New Bid Date and Time 3:00 PM, Wednesday, May 30, 2012

ADDENDUM 2

Project Name: **Hale Stadium Renovations
Tennessee State University**
Owner: **Tennessee Board of Regents**
Address: **Office of Facilities Development
Suite 664 (6th Floor, southwest) Genesco Office Park
1415 Murfreesboro Road
Nashville, TN 37217-2833**
City, State:
Project Number **SBC #166/002-02-2011
HFR# 2011171.00**
Date: **May 18, 2012**
From: **HFR Design, Inc.
7101 Executive Center Drive, Suite 300
Brentwood, TN 37027**

**POWER &
SYSTEMS-
FLOOR PLANS**

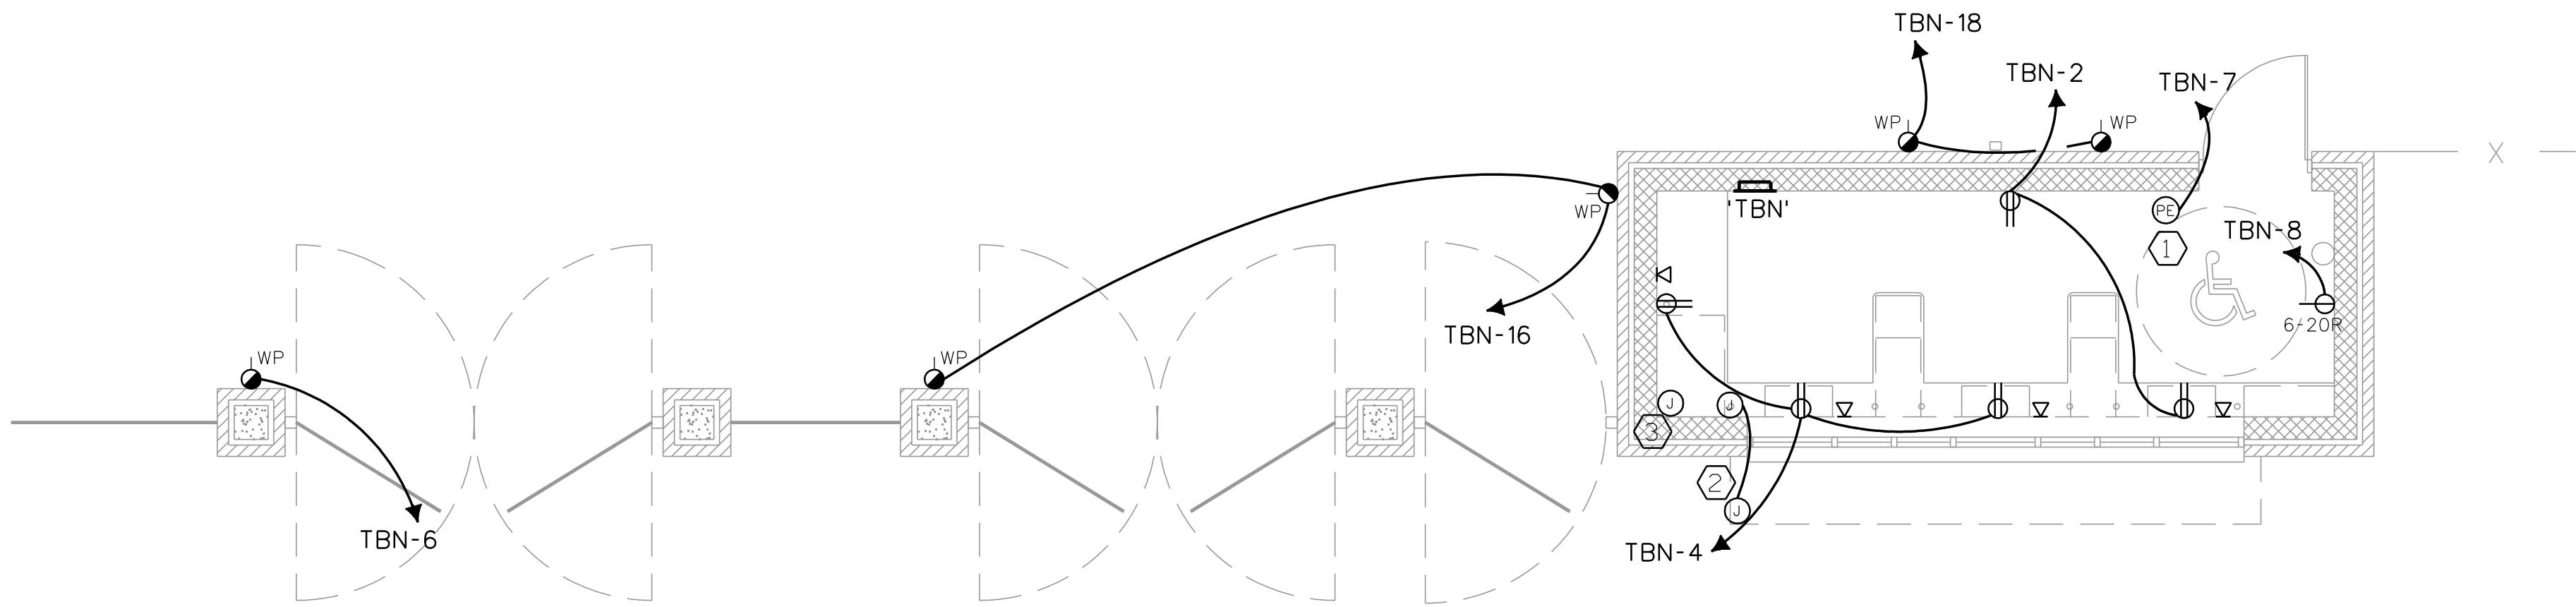
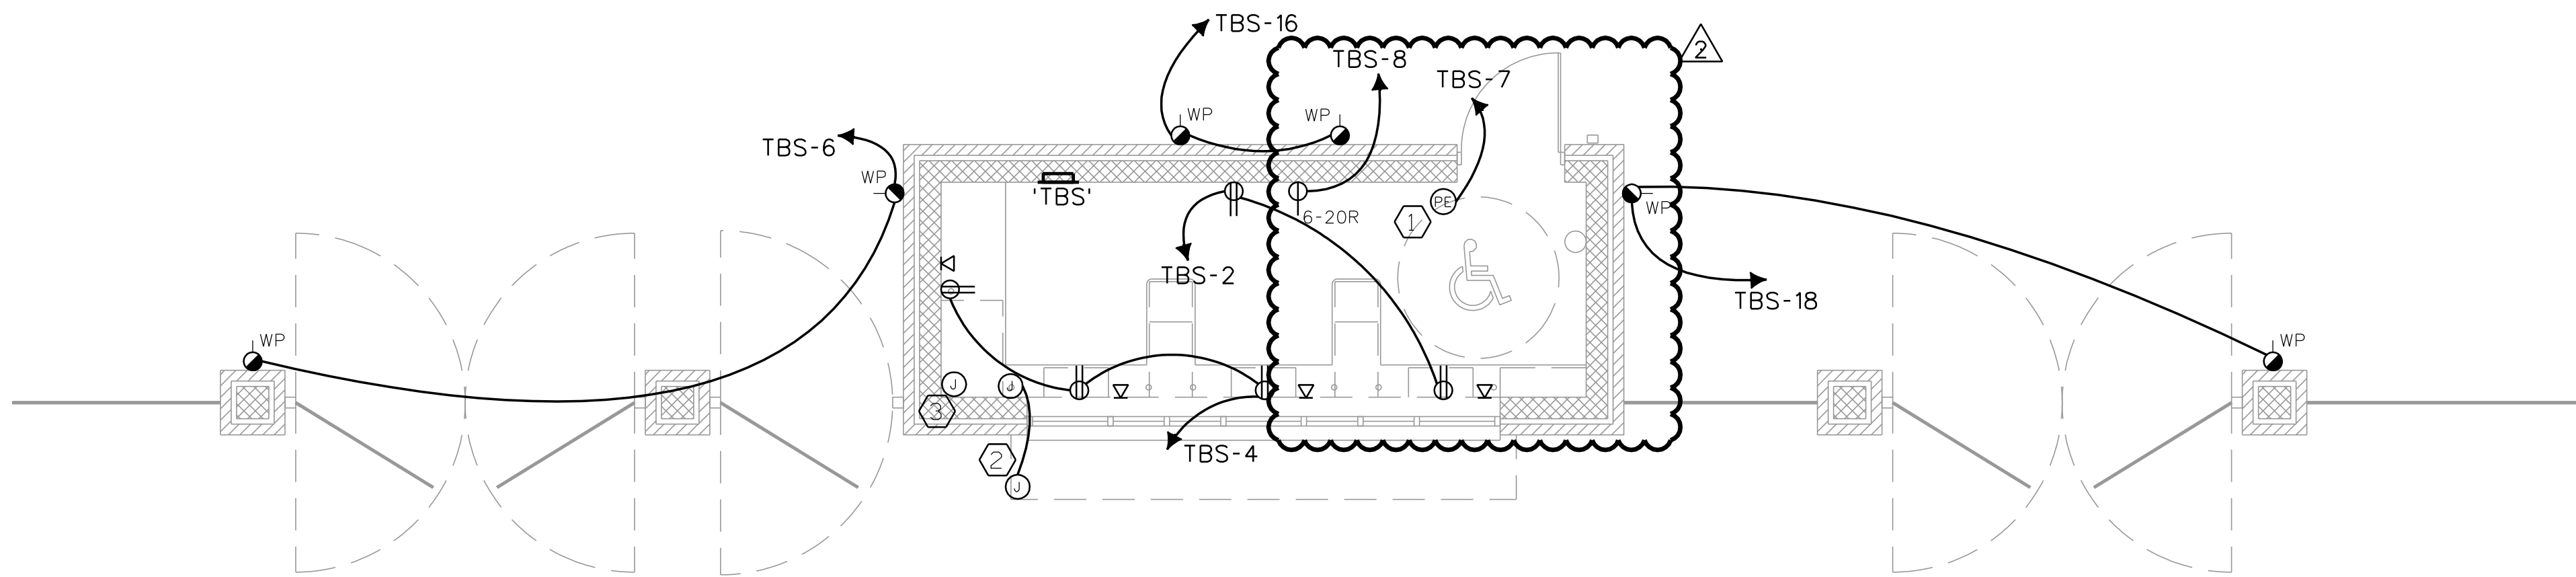
- 2-33. Drawing E2.01: Revise electrical receptacle for the air conditioner in the Ticket Booth per included drawing.
